MOUNTAINS RECREATION & CONSERVATION AUTHORITY
Ramirez Canyon Park
5810 Ramirez Canyon Road
Malibu, California 90265
Phone (310) 589-3230 Fax (310) 589-3237

April 7, 2017

Pacific Coast Highway Parking Study Draft Final Report

Near Escondido Beach - 27910 PCH
(ocean side)

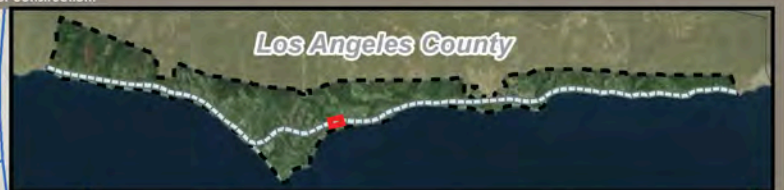
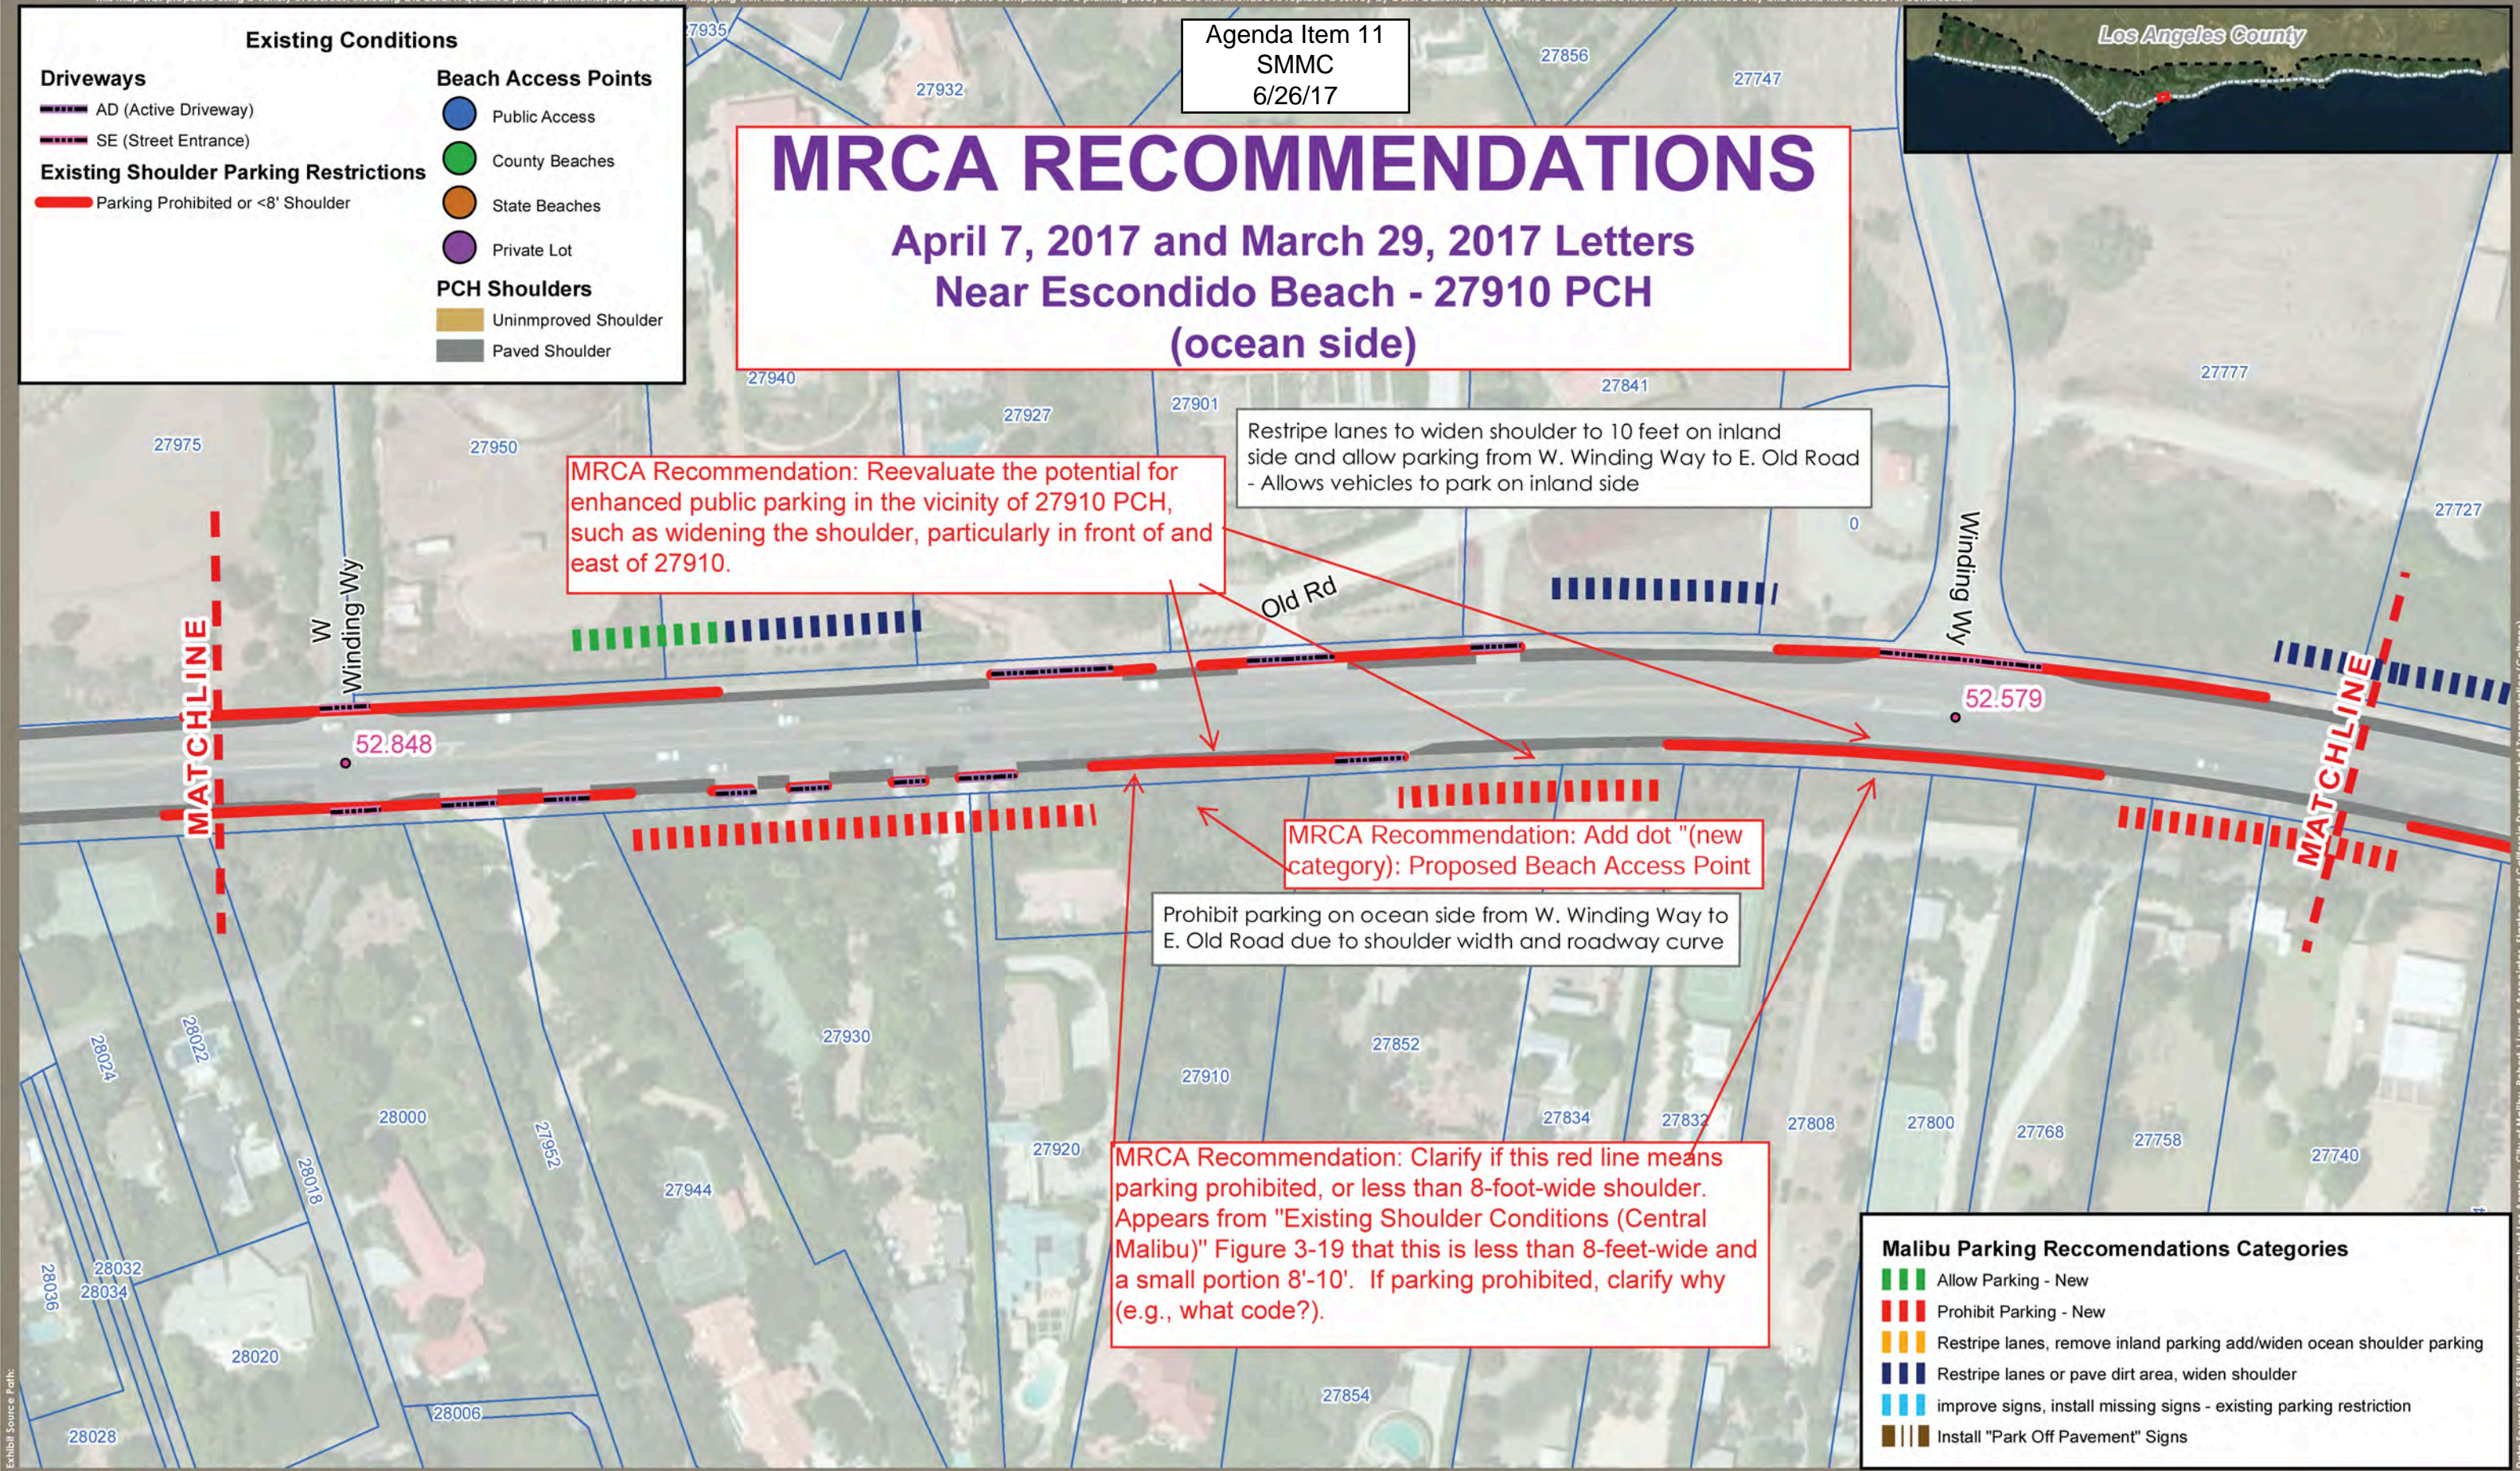
MRCA Recommendation: Reevaluate the potential for enhanced public parking in the vicinity of 27910 PCH, such as widening the shoulder, particularly in front of and east of 27910.

MRCA Recommendation: Add dot "(new category): Proposed Beach Access Point

MRCA Recommendation: Clarify if this red line means parking prohibited, or less than 8-foot-wide shoulder. Appears from "Existing Shoulder Conditions (Central Malibu)" Figure 3-19 that this is less than 8-foot-wide and a small portion 8'-10'. If parking prohibited, clarify why (e.g., what code?).

Near Meadows Court (inland side) and
Geoffrey's Restaurant (ocean side)

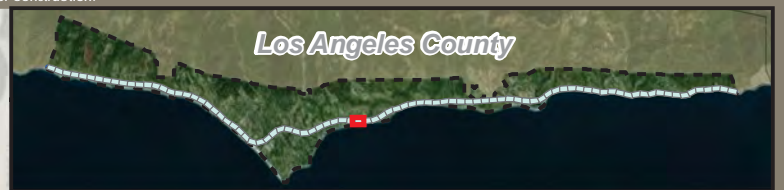
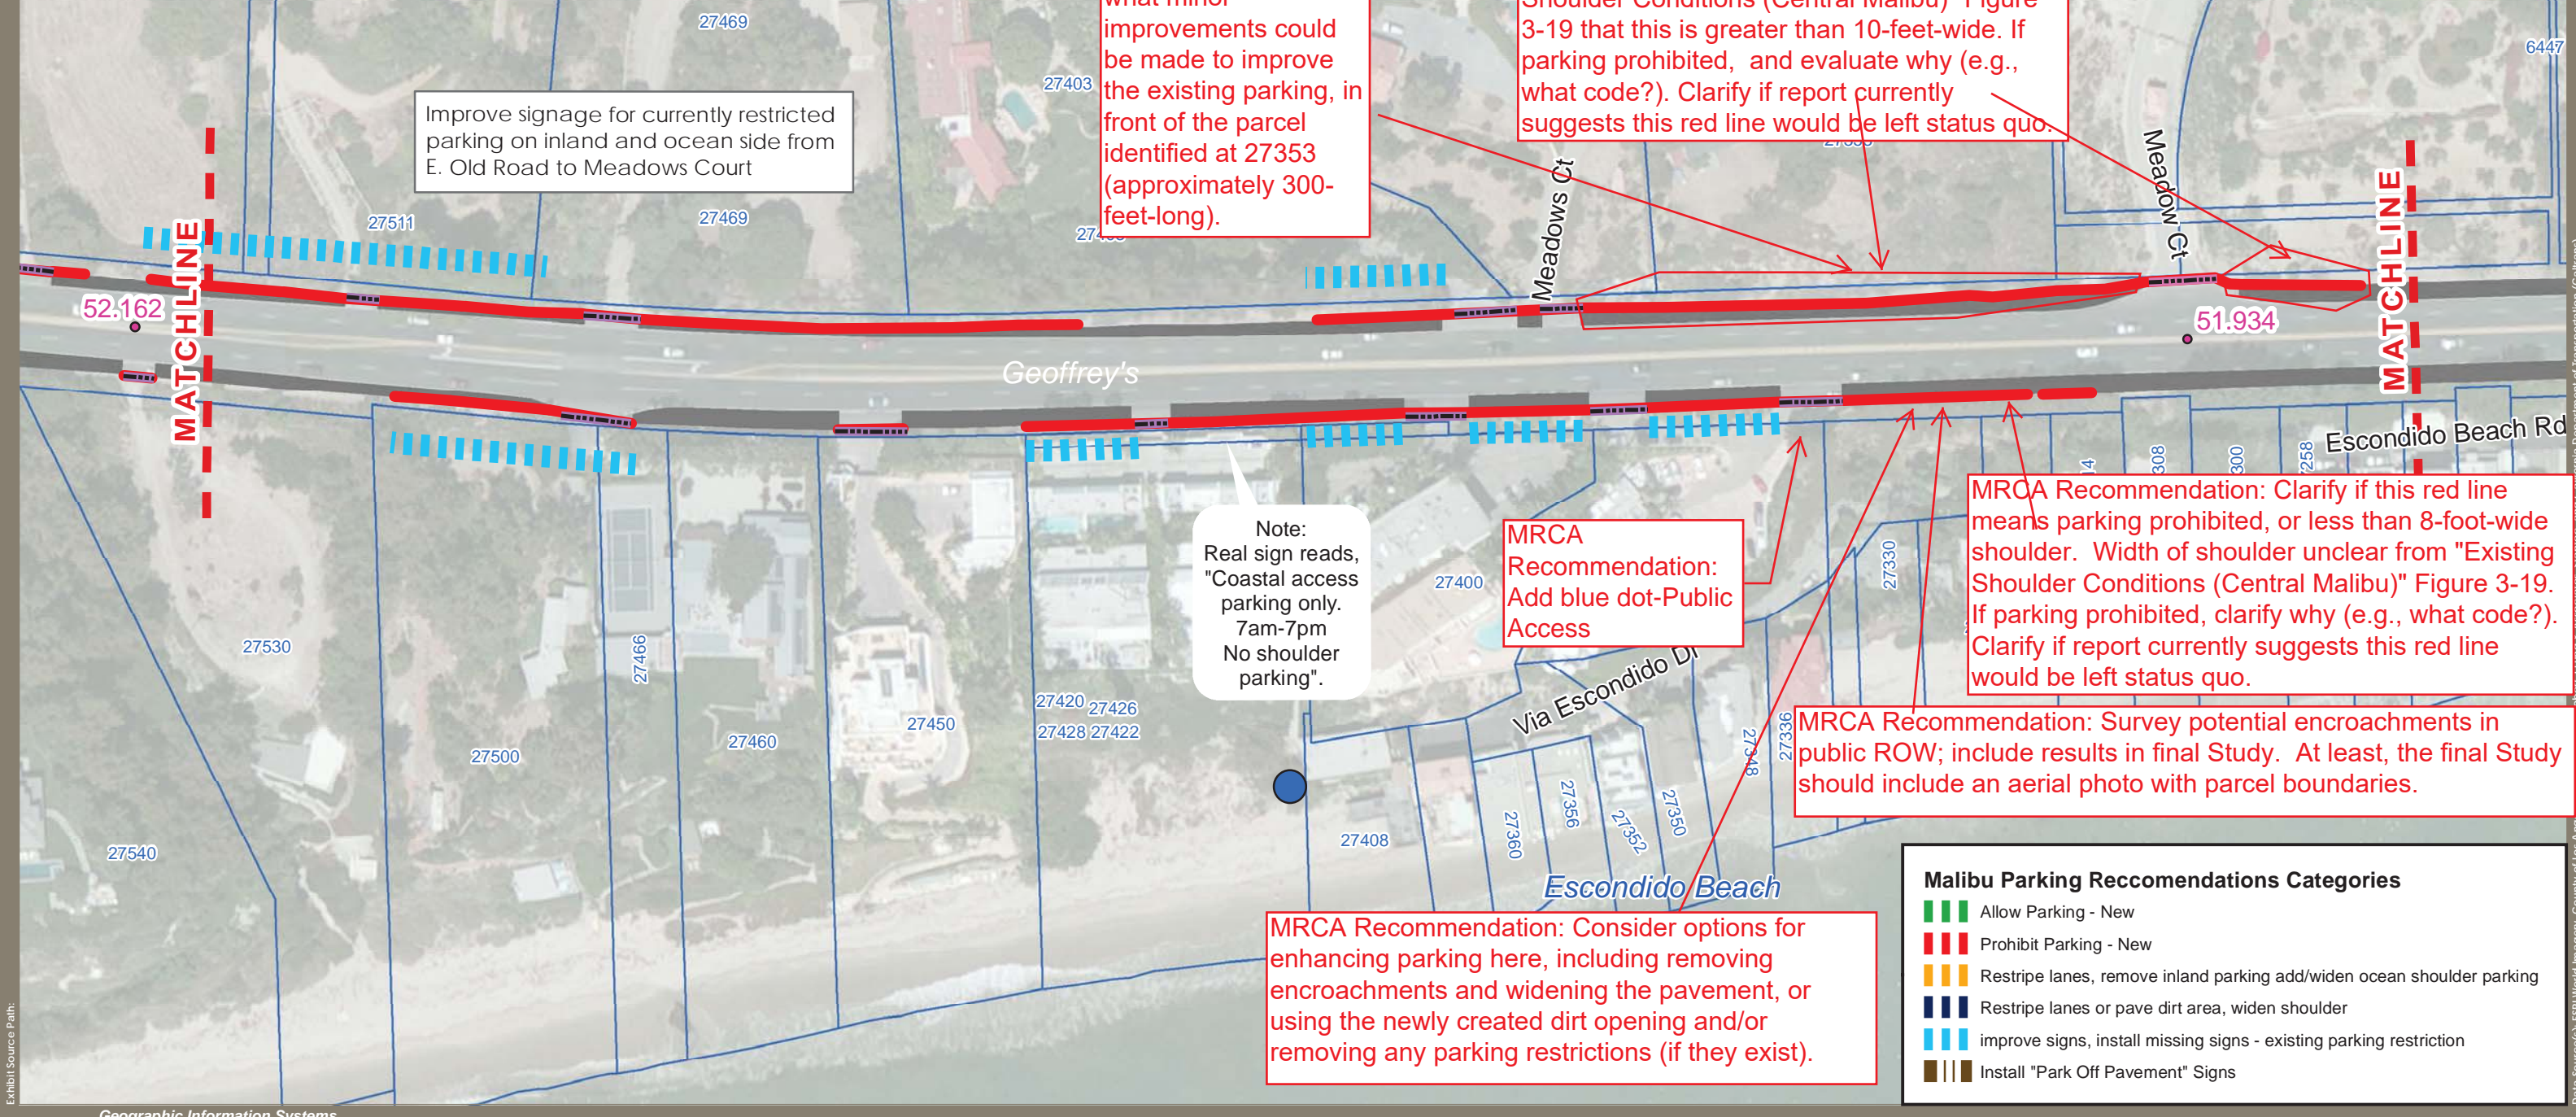
MRCA Recommendation: Report should identify what minor improvements could be made to improve the existing parking, in front of the parcel identified at 27353 (approximately 300-foot-long).

MRCA Recommendation: Clarify if this red line means parking prohibited, or less than 8-foot-wide shoulder. Appears from "Existing Shoulder Conditions (Central Malibu)" Figure 3-19 that this is greater than 10-foot-wide. If parking prohibited, and evaluate why (e.g., what code?). Clarify if report currently suggests this red line would be left status quo.

MRCA Recommendation: Add blue dot-Public Access

MRCA Recommendation: Clarify if this red line means parking prohibited, or less than 8-foot-wide shoulder. Width of shoulder unclear from "Existing Shoulder Conditions (Central Malibu)" Figure 3-19. If parking prohibited, clarify why (e.g., what code?). Clarify if report currently suggests this red line would be left status quo.

MRCA Recommendation: Survey potential encroachments in public ROW; include results in final Study. At least, the final Study should include an aerial photo with parcel boundaries.

MRCA Recommendation: Consider options for enhancing parking here, including removing encroachments and widening the pavement, or using the newly created dirt opening and/or removing any parking restrictions (if they exist).

Near Meadows Court (inland side) and Via Escondido Drive (inland side)

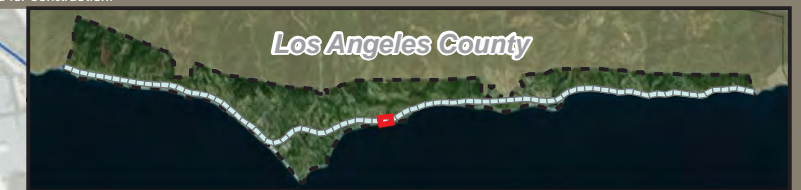
MRCA Recommendation: clarify over what distance the Stantec recommendation applies to improve signage to clearly prohibit parking in the bus zones. It should be just near the bus stops.

MRCA Recommendation: Clarify if this red line means parking prohibited, or less than 8-foot-wide shoulder. Appears from "Existing Shoulder Conditions (Central Malibu)" Figure 3-19 that this is "<8 ft." and "Existing unpaved should could accommodate widening to 8' paved area."

MRCA Recommendation: Implement enhancements to improve public parking (e.g., widen pavement to at least 8-foot-wide)

MRCA Recommendation: Clarify if this red line means parking prohibited, or less than 8-foot-wide shoulder. Appears from "Existing Shoulder Conditions (Central Malibu)" Figure 3-19 that this is "8-10ft." with a small part "<8 ft." If parking prohibited, clarify why (e.g., what code?).

MRCA Recommendation: Explore widening the pavement into dirt areas in order to enhance public parking in some of this area, while still maintaining adequate site distance to Via Escondido Drive.
